Your ref: Tilbuster 2 Solar Farm (SSD-69799460)
Our ref: 12636761

16 June 2026

Tilbuster 2 Solar Farm Response to Submissions Report – Request for Additional Information

Figure 5.1 Proposal overview

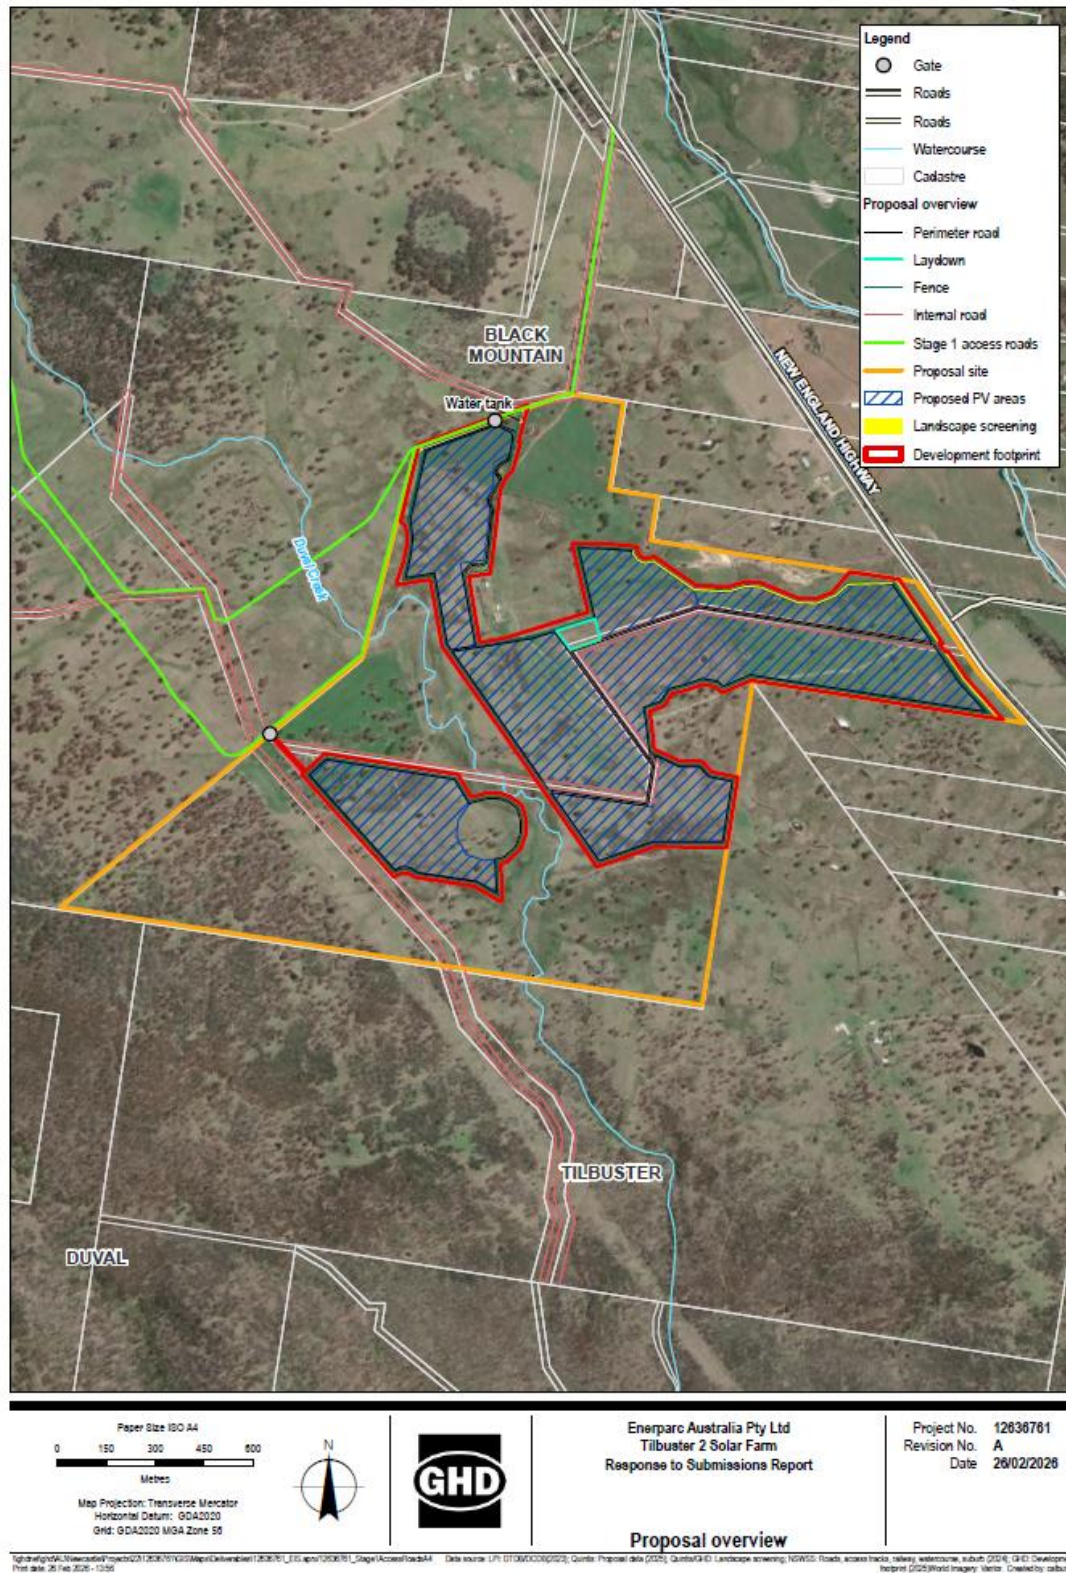
The DPHI requested a revised proposal figure showing the internal access road connections to Stage 1 of the Tilbuster Solar Farm. This is shown in Figure 5.1.

Annexure A – Flood Maps

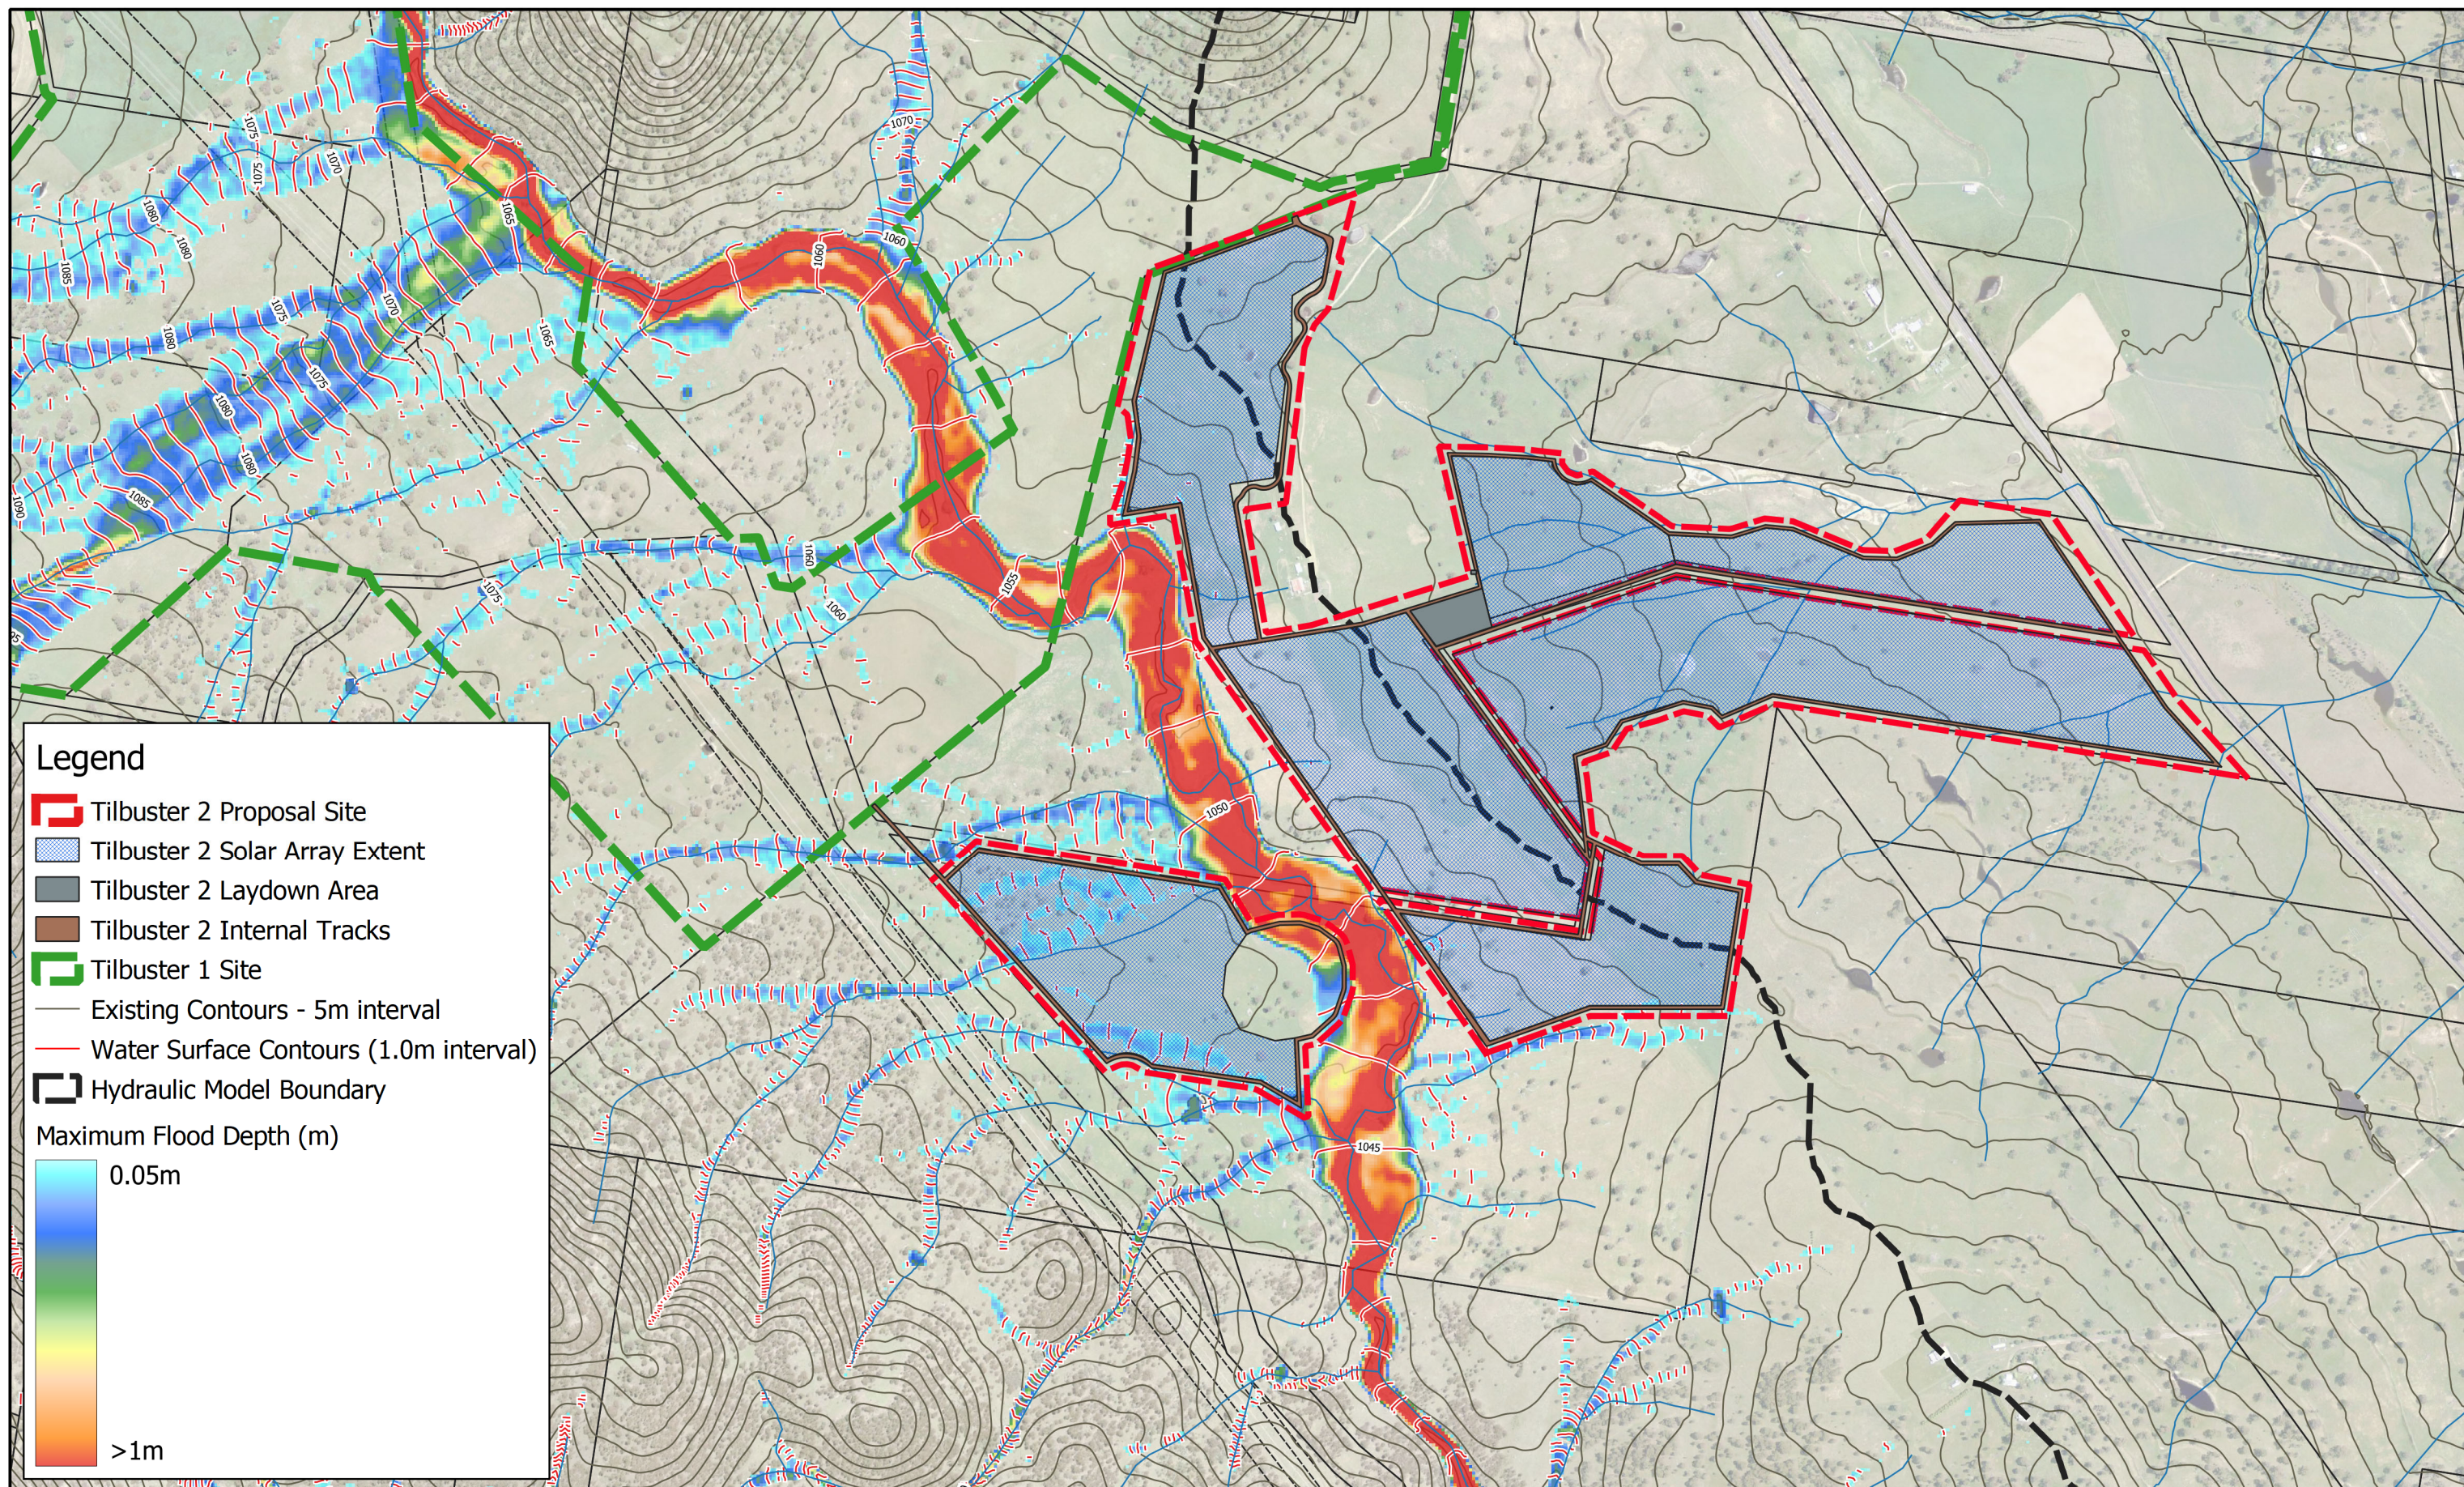
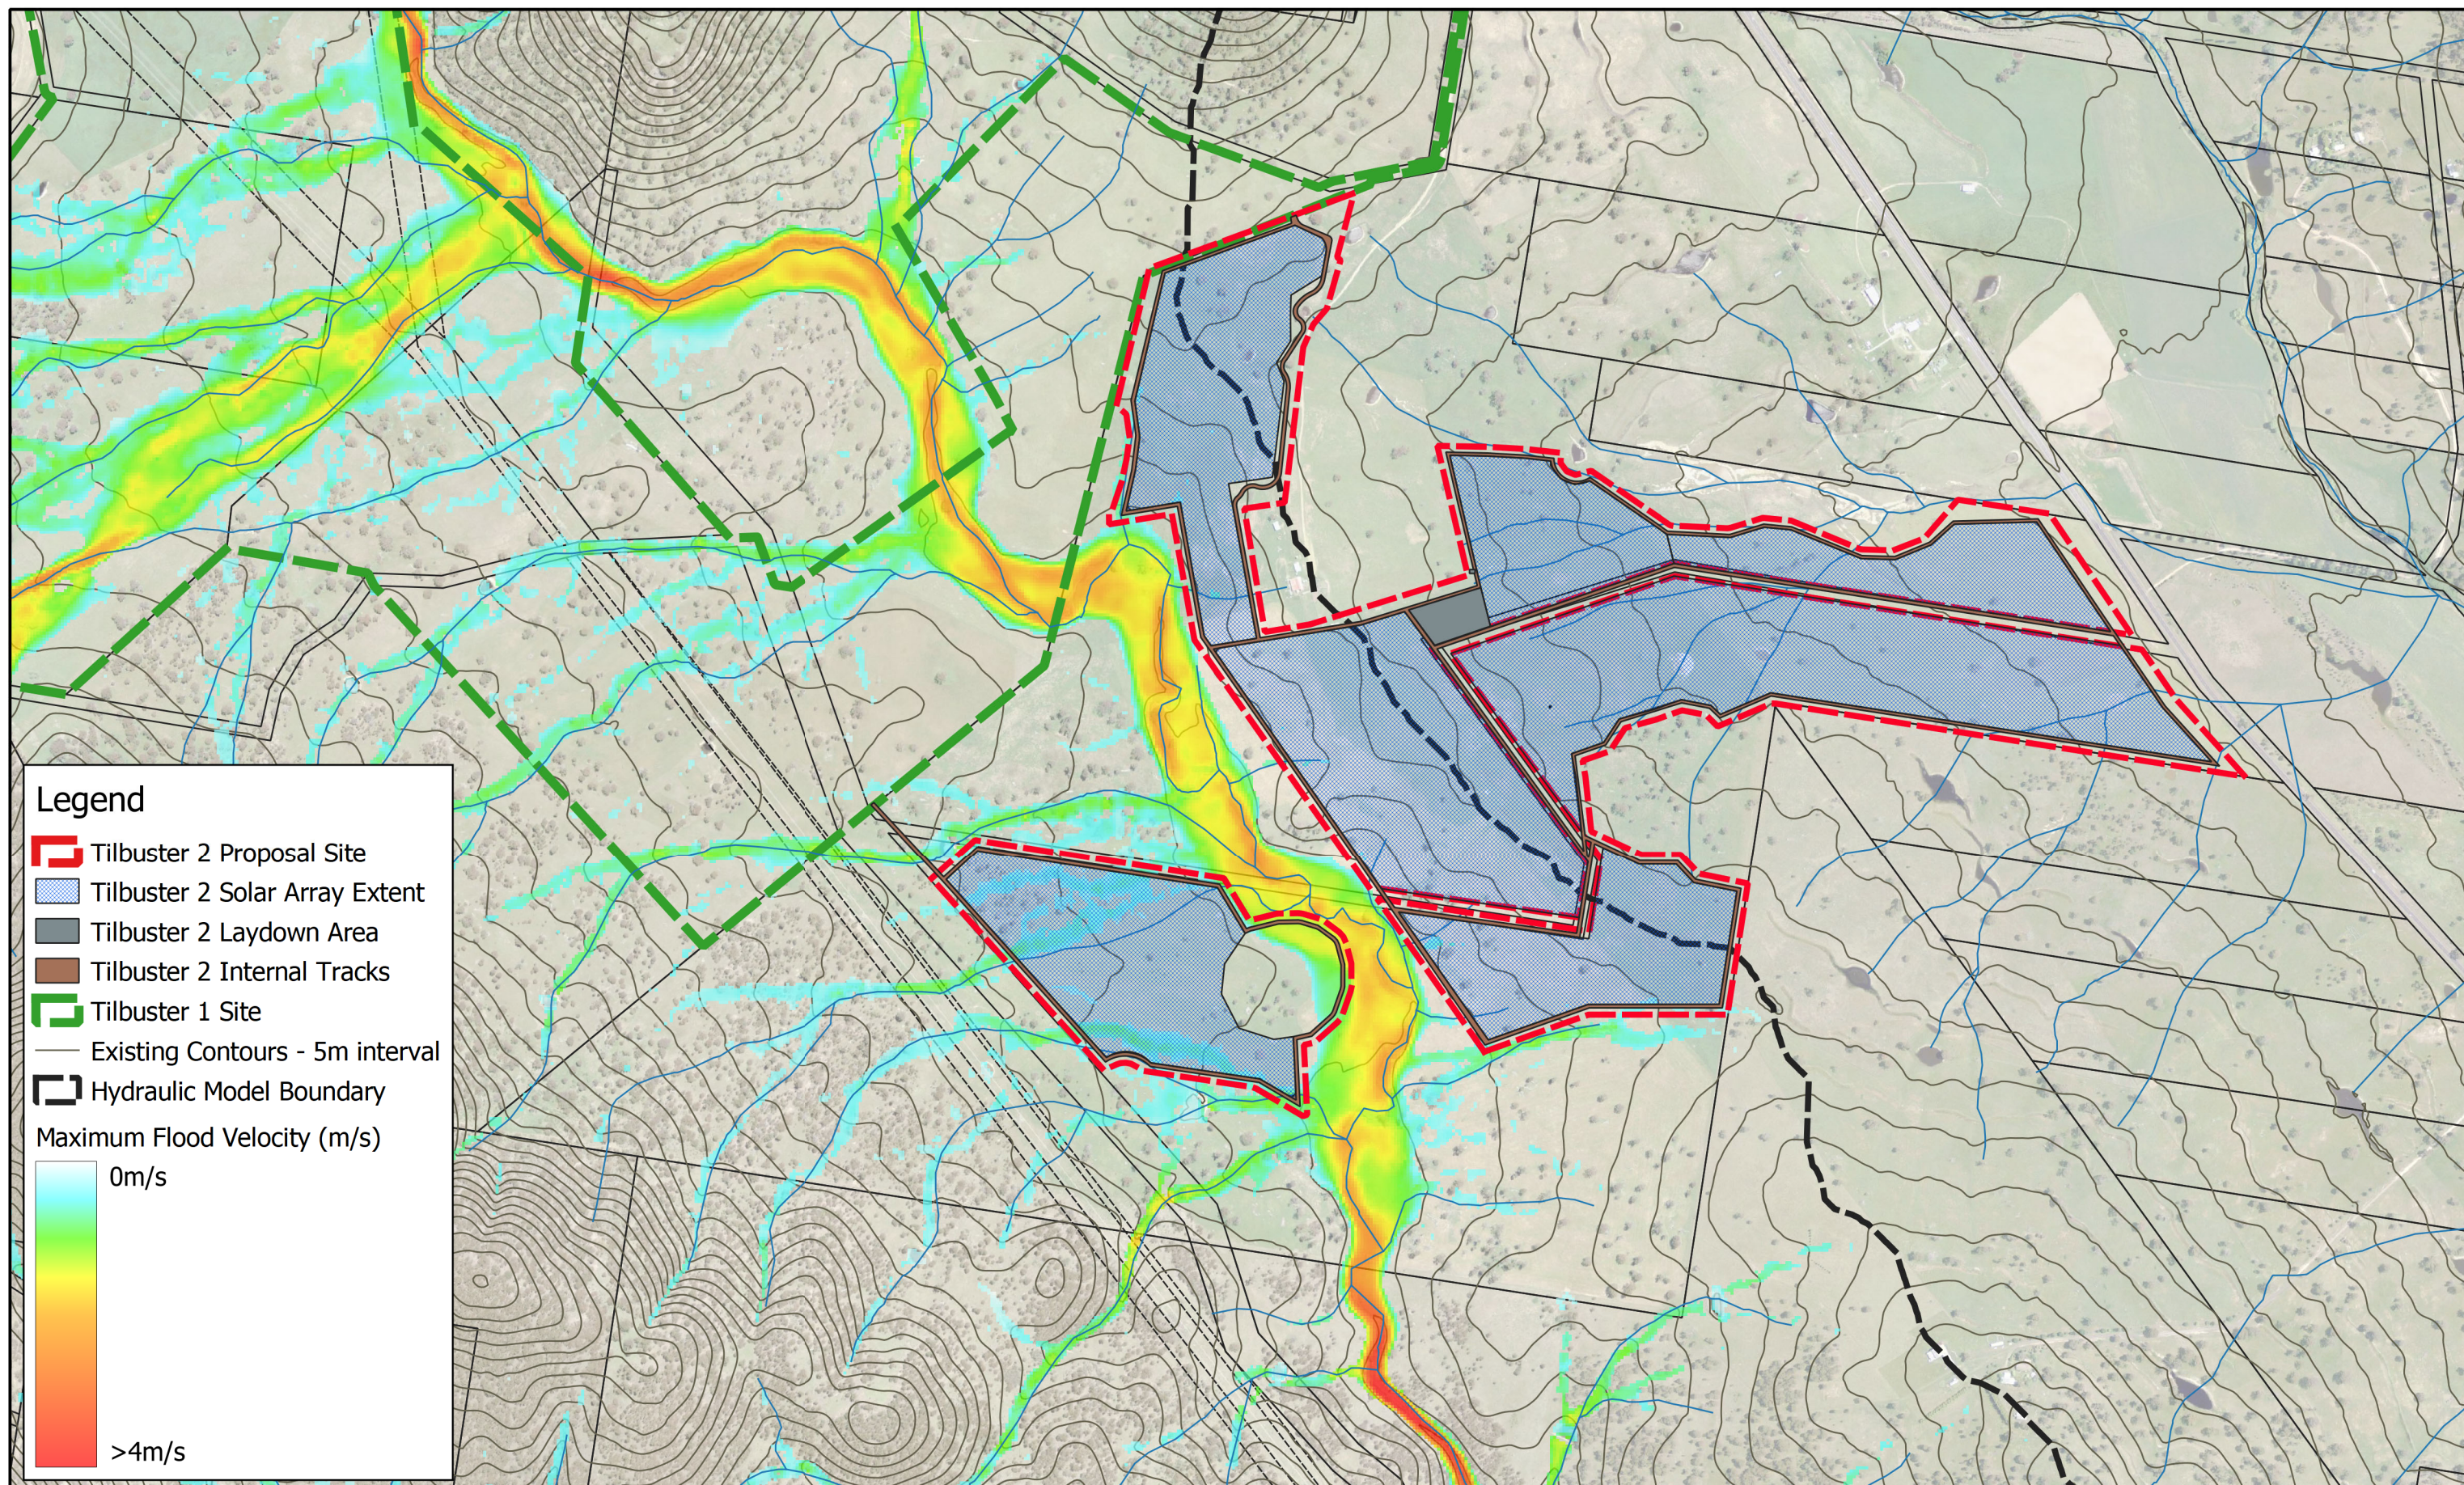
The Department of Planning, Housing and Infrastructure (DPHI) have requested pre and post development flood mapping for the proposal site. This is provided in Attachment 1.

The Tilbuster 2 site layout has been overlaid on the pre-development flood mapping prepared for the Tilbuster project and a copy of this mapping is included in Annexure A.

The figures show that the extent of the proposed solar array for Tilbuster 2 is typically clear of the extent of fluvial flooding associated with Duval Creek for the 5% AEP and 1% AEP events. Some areas on the western side of Duval Creek are impacted in the PMF event; however, these are generally outside the H6 hazard in that event. Otherwise, minor overland flooding is shown to occur through the solar arrays west of Duval Creek over first and second or watercourses (ephemeral depressions) in this area, however these flows are of low hazard (H1-H2) in all events.

Given that the proposed solar arrays are to be largely located outside areas of high flood hazard the proposed works are unlikely to result in an adverse impact on flooding within Duval Creek provided that the flood management recommendations contain in Section 6.0 of the Tilbuster Report are applied to this development.
